Replies to reviews

“Technical note: What does the Standardized Streamflow Index actually reflect? Insights and implications for hydrological drought analysis

Fabián Lema, Pablo A. Mendoza, Nicolás Vásquez, Naoki Mizukami, Mauricio Zambrano-Bigiarini, and Ximena Vargas

Figure 1: Same as in Fig. 1 in the main document, but with the same range for the y-axis, as suggested by the reviewer.

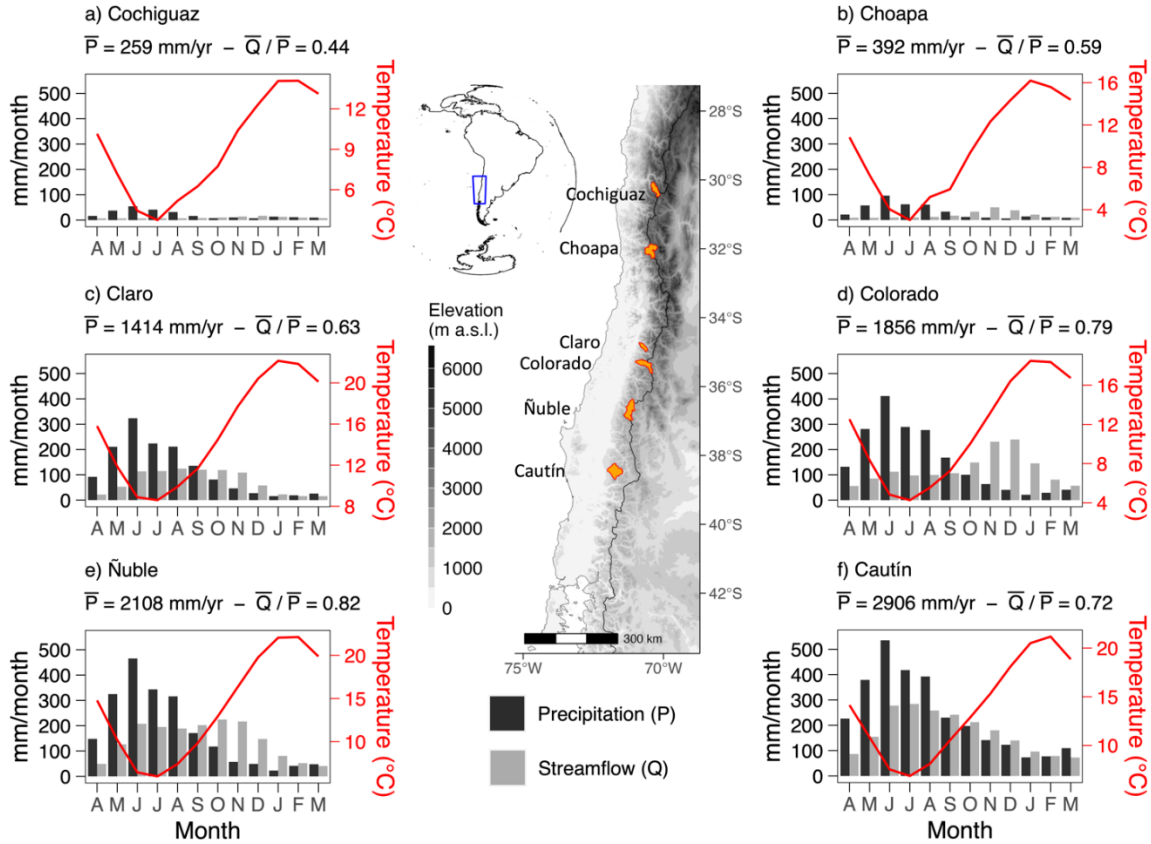
Figure 1: Add yellow catchment indicators to the legend. Standardize the y-axis scale for mm/month and temperature to enable better comparison between catchments.

We appreciate the reviewer's suggestion. A new version of Fig. 1 is displayed below, using the same range for the primary y-axis in all the catchments, as suggested by this reviewer.

Since monthly precipitation and streamflow values are very difficult to distinguish for the Cochiguaz and Choapa River basins, we prefer to keep the original version of Fig. 1, as it provides a better visualization of the annual cycles in each basin. Additionally, we have modified the caption of Fig.1 in the main document as follows:

“Location, delimitation (orange area in map) and seasonality of precipitation (P), runoff (Q) and temperature for the six case study basins: (a) Cochiguaz River at El Peñón, (b) Choapa River at Cuncumén, (c) Claro River at El Valle, (d) Palos River at Colorado, (e) Ñuble River at La Punilla, and (f) Cautín River at Rari-Ruca. Overlines represent annual averages for the period April/1985-March/2015.”

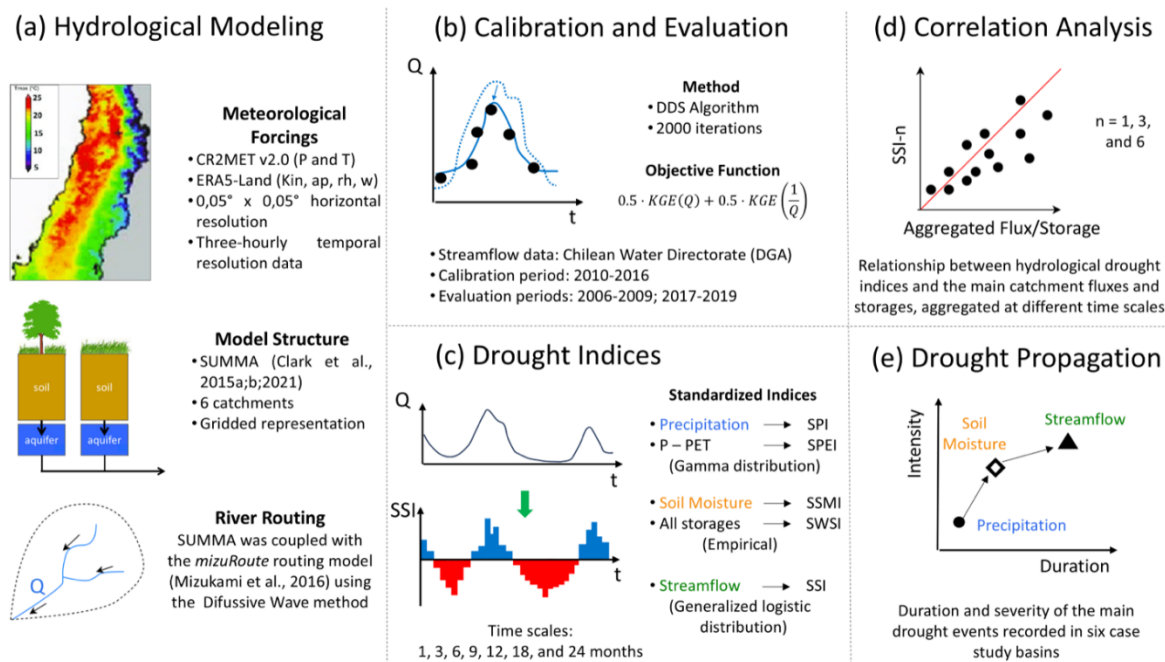
Figure 2: Define all acronyms directly in the figure legend (e.g., pp, temp, Kin, SPI, SPEI, etc.). Avoid phrases like "See text for details." The figure caption should be self-contained.

In response to this suggestion, we have revised all figure captions, removing the phrases “see text for details”, and defining all the acronyms in the figure captions, as suggested by this reviewer. In particular, we have modified the caption of Figure 2 as follows:

“Figure 2. Flowchart describing the approach used in this study, including: (a) meteorological forcings, hydrological model structure and river routing configuration (section 3.1); (b) calibration and evaluation of hydrological models (section 3.2); (c) calculation of drought indices at different time scales (section 3.3); (d) correlation analysis between standardized drought indices and aggregated fluxes/storages (section 3.4); and (e) drought propagation analysis (section 3.5). The abbreviations/acronyms used in the figure are as follows: P – precipitation; T – air temperature; Kin – incoming shortwave radiation; ap – atmospheric pressure; rh – relative humidity; w – wind speed; SPI – Standardized Precipitation Index; SPEI – Standardized Precipitation and Evapotranspiration Index; SSMI – Standardized Soil Moisture Index; SWSI – Standardized Water Storage Index; SSI – Standardized Streamflow Index.”

Also, a new version of Fig. 2 is displayed below, in which the acronym “pp” has been changed to “P” when referring to precipitation, in order to maintain clarity and consistency with the rest of the document.
